Upper Silver Creek Restoration Project Year 4 Monitoring Report

NCDMS Project ID Number – 94645

**Burke County, North Carolina
NCDMS Project ID Number – 94645**

Subject: Response to DMS comments on the Year 4 Monitoring Report Review for the Upper Silver Creek Stream and Wetland Restoration Project; Catawba River Basin - CU# 03050101; Burke County, North Carolina; NCEEP Project # 94645; Contract No. 003270

Monitoring Year 4 Profile of UT2, Station 0+00 to 3+20
Data collected October, 2018

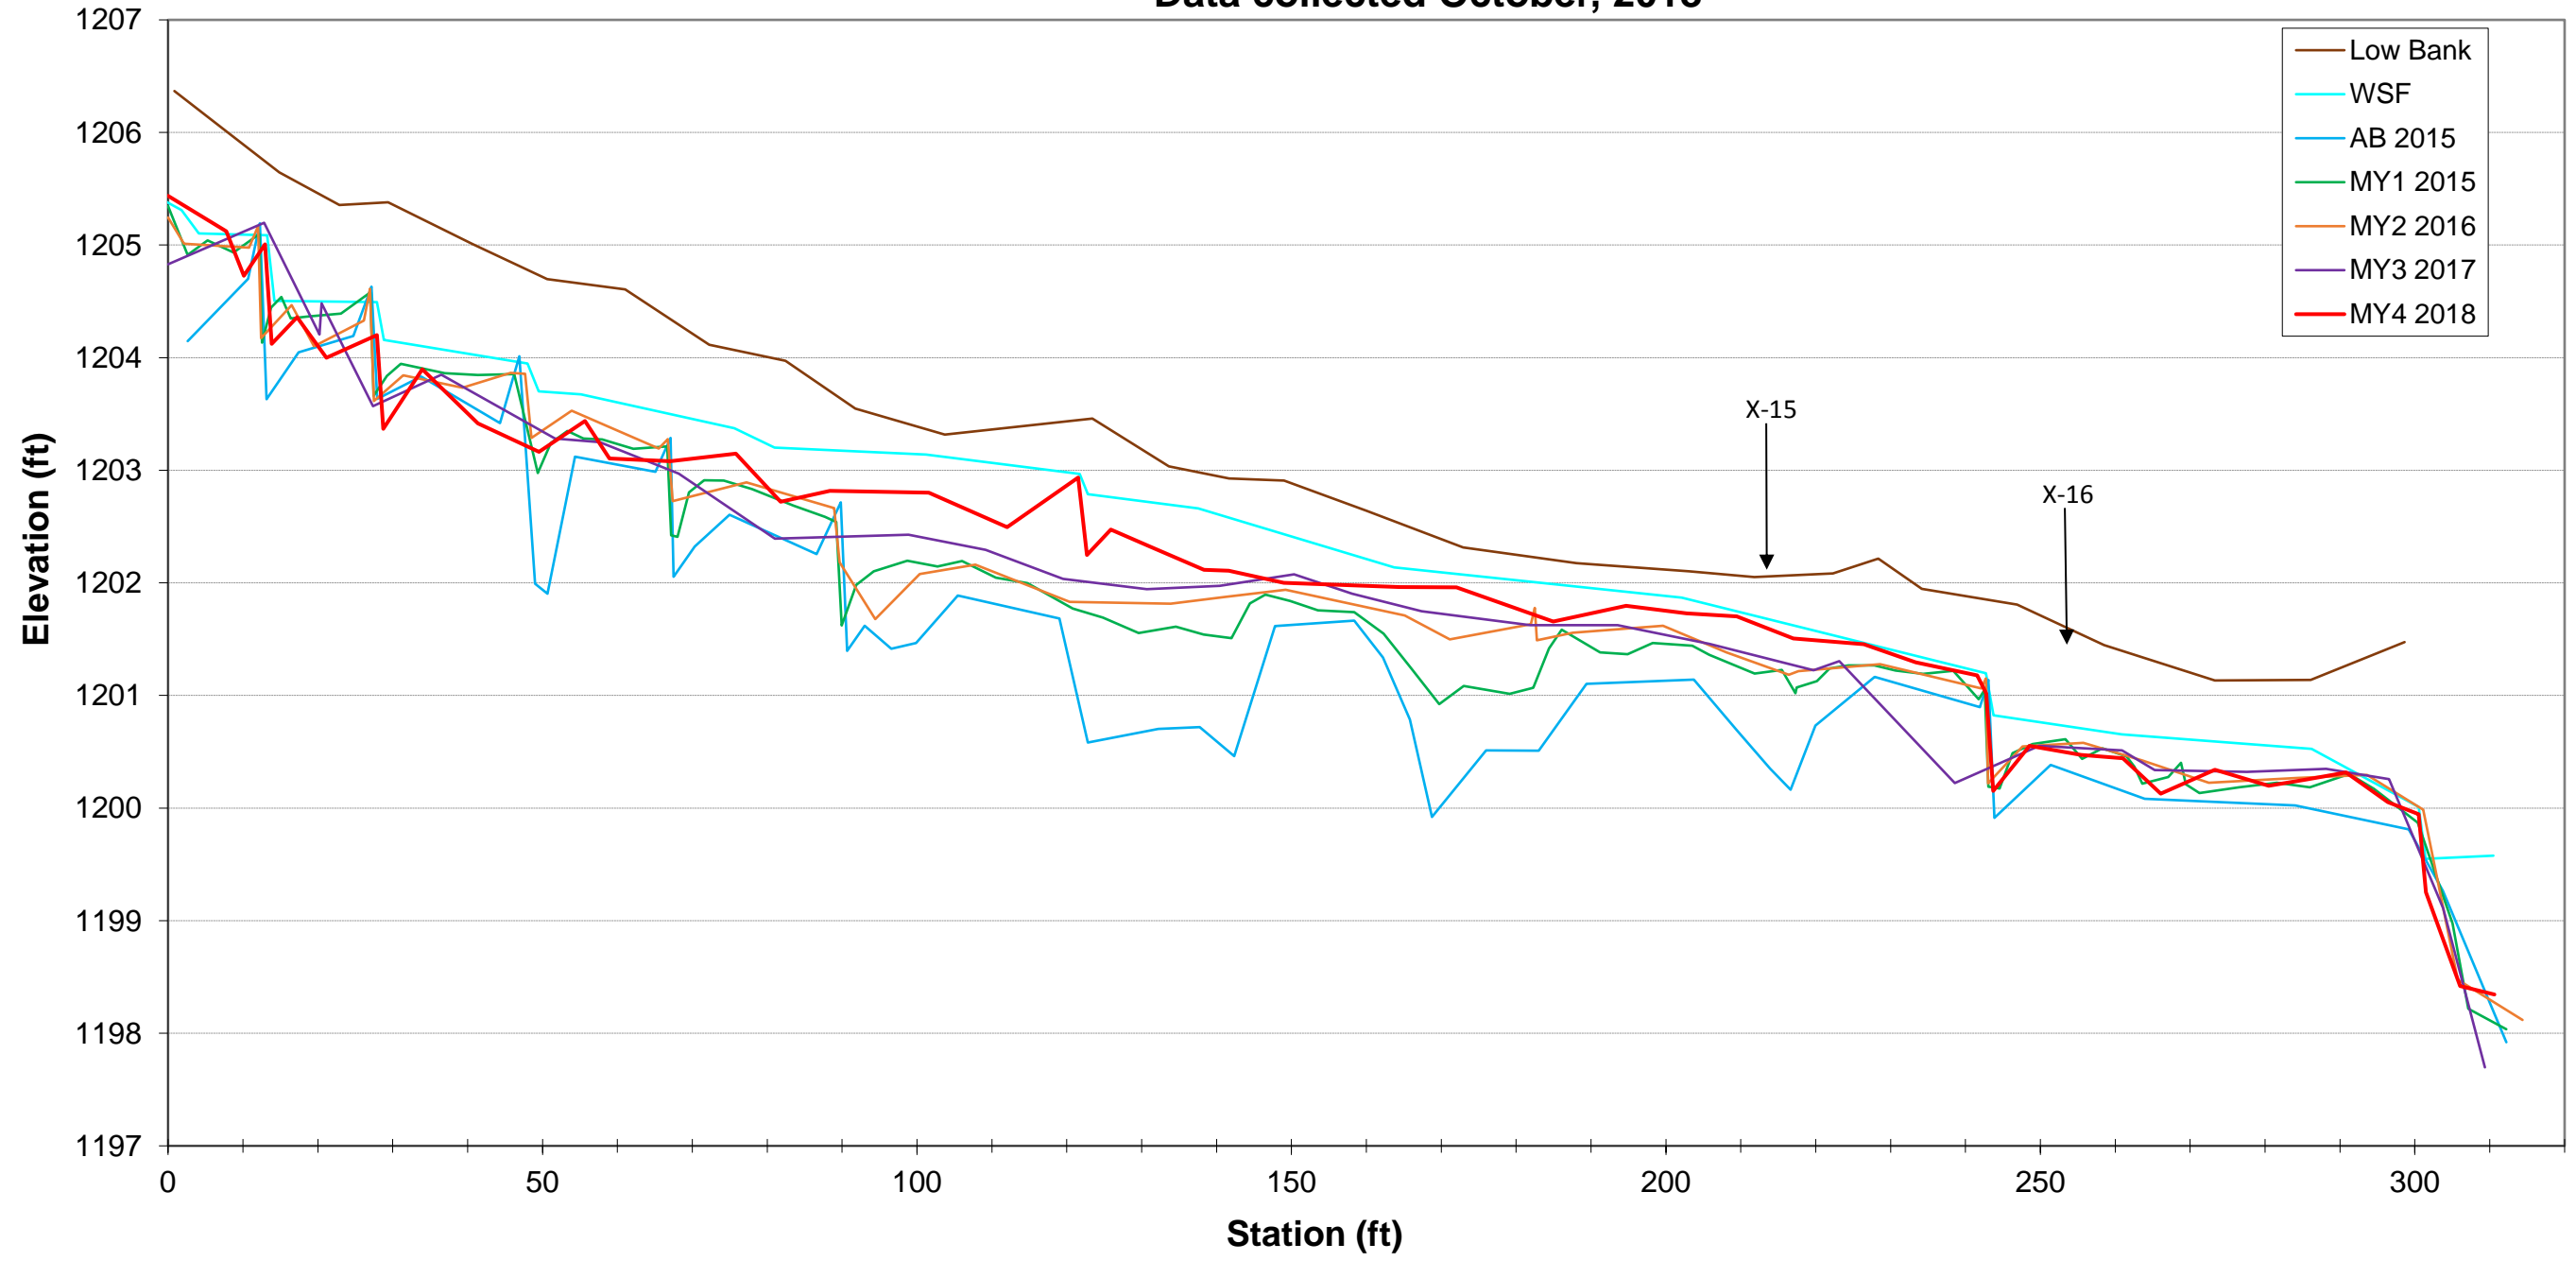
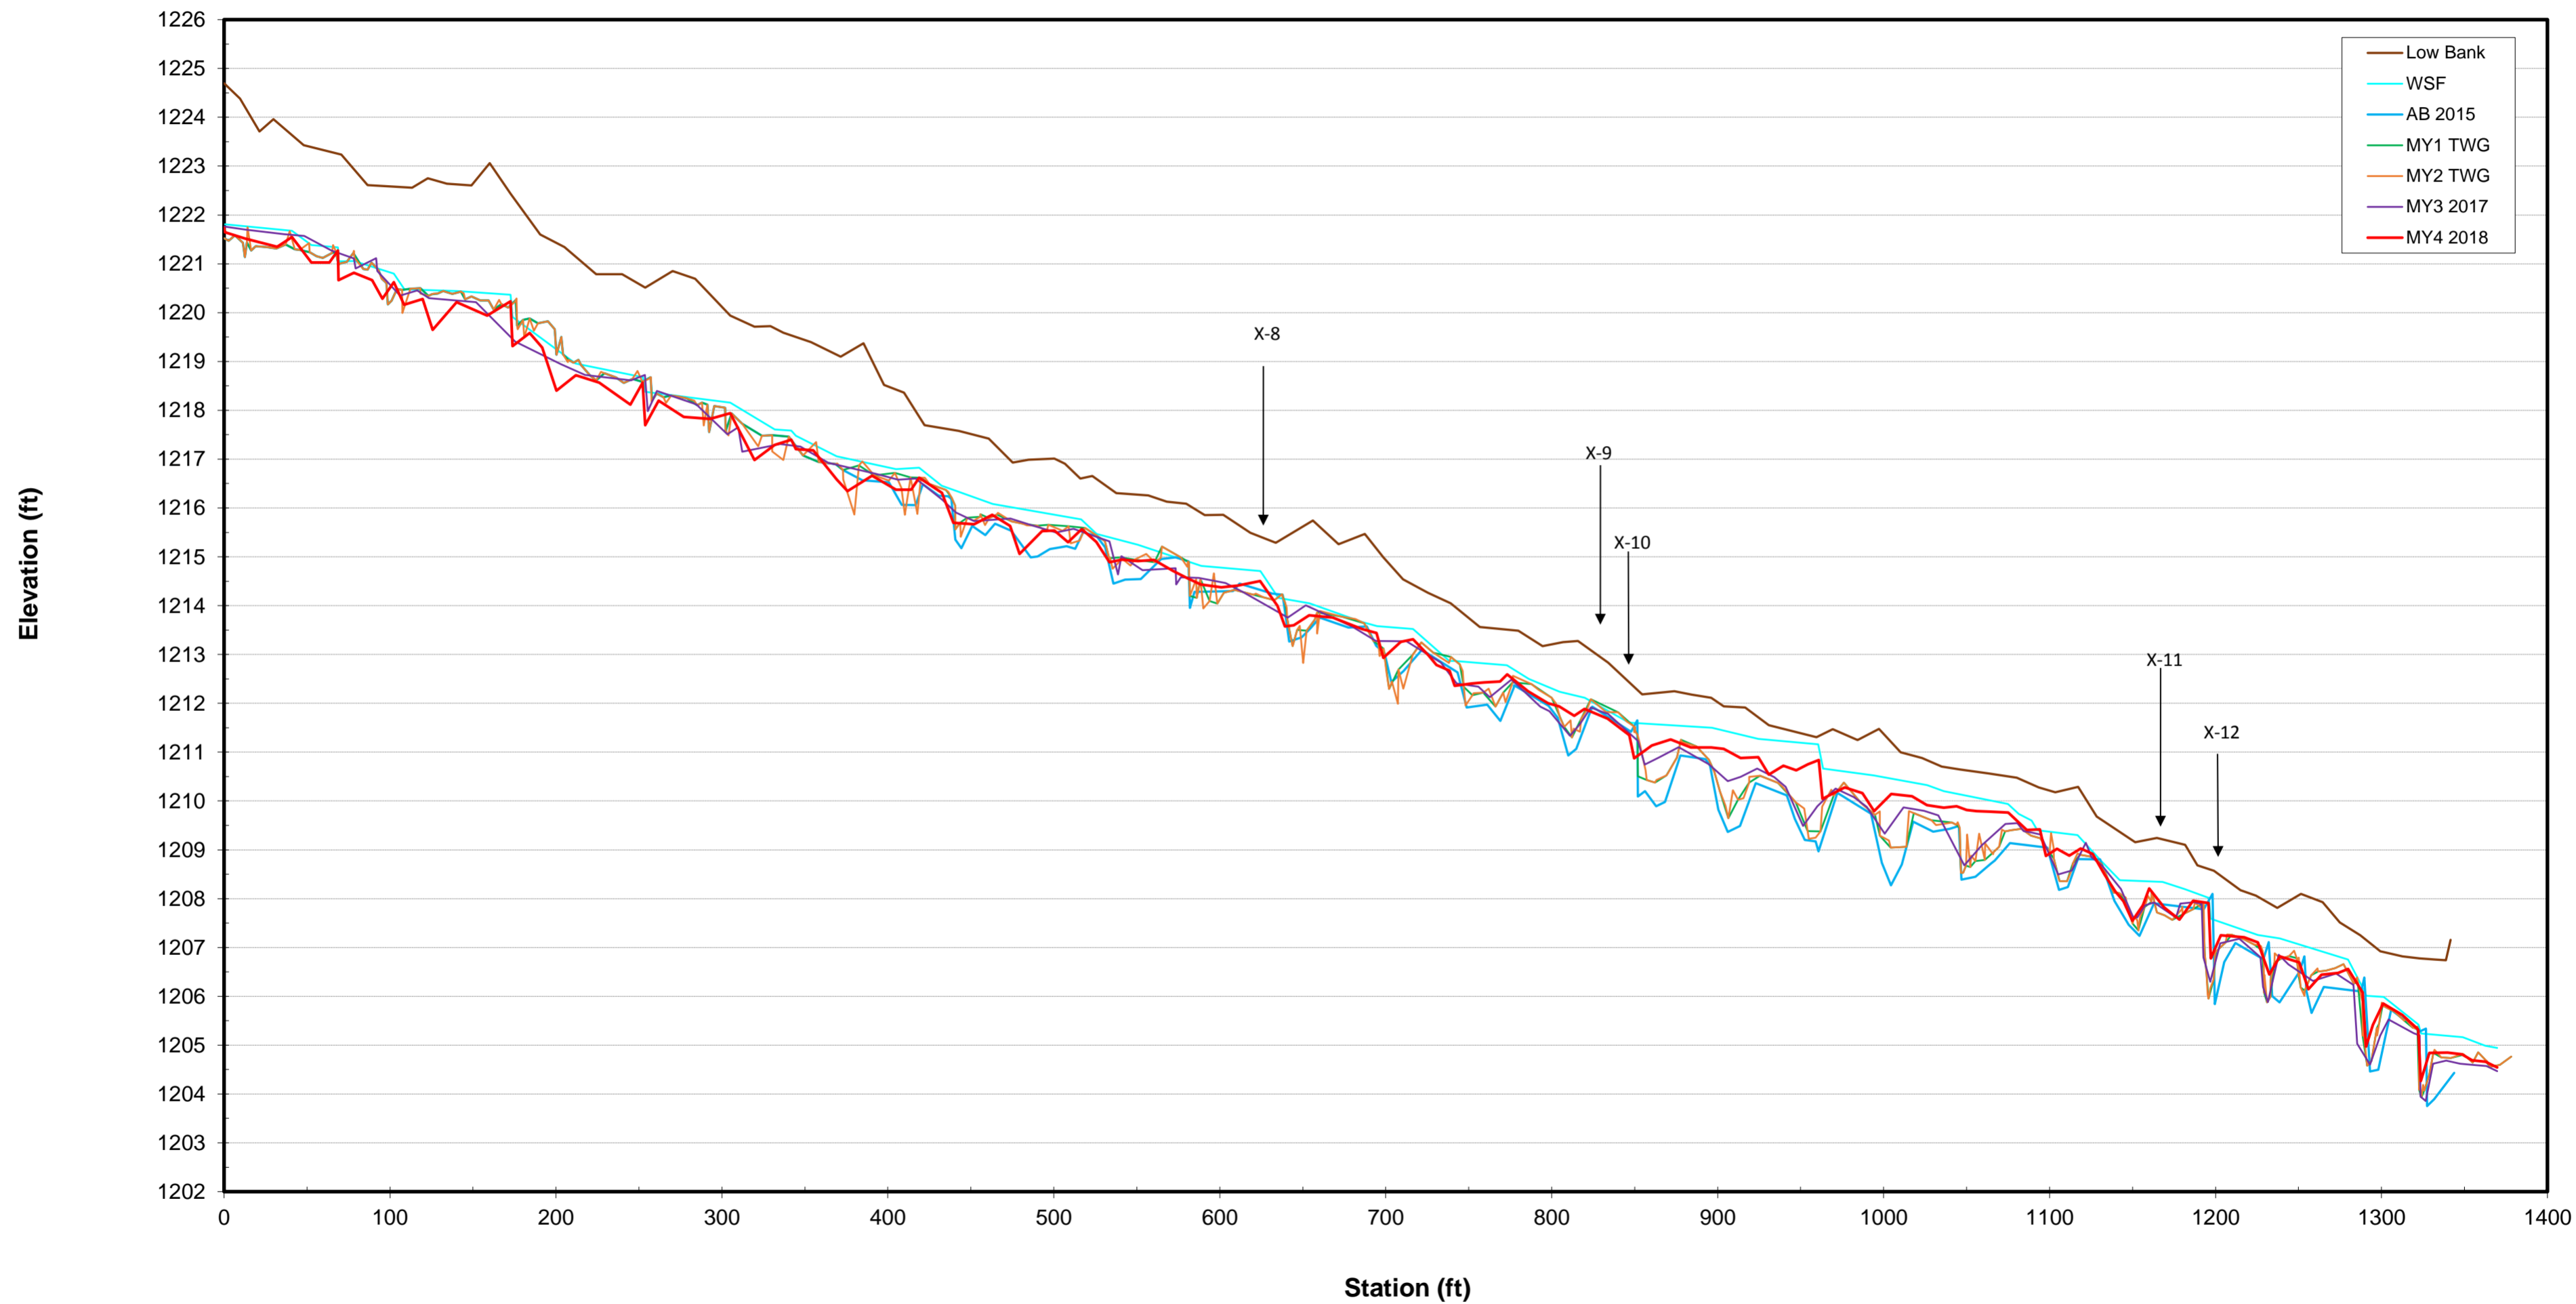
- The UT2 profile and sections of UT3 indicate significant aggradation. As Baker is aware, the USACE will be looking at defined bed/bank and often denies credit for channels that have become filled with sediment. I am aware of the large upstream sediment sources from past mining activities on UT2. Please add a short discussion in section 2.2.1 regarding this issue. Does Baker have any corrective action or adaptive management planned for these reaches?

We have added more information to the discussion of aggradation in section 2.2.1. We do indicate that we will monitor the areas of aggradation indicated by the cross-sections and general project channels, to be sure that sandy material that has moved into the project reach due to the unusually high flows of this year, is moving through the system. We will specifically evaluate UT2 and areas of UT3 to evaluate ways that we can enhance sediment transport or directly remove accumulated sediment as needed. In some locations this likely will involve removal of vegetation (cattails) or woody debris that is causing aggradation.
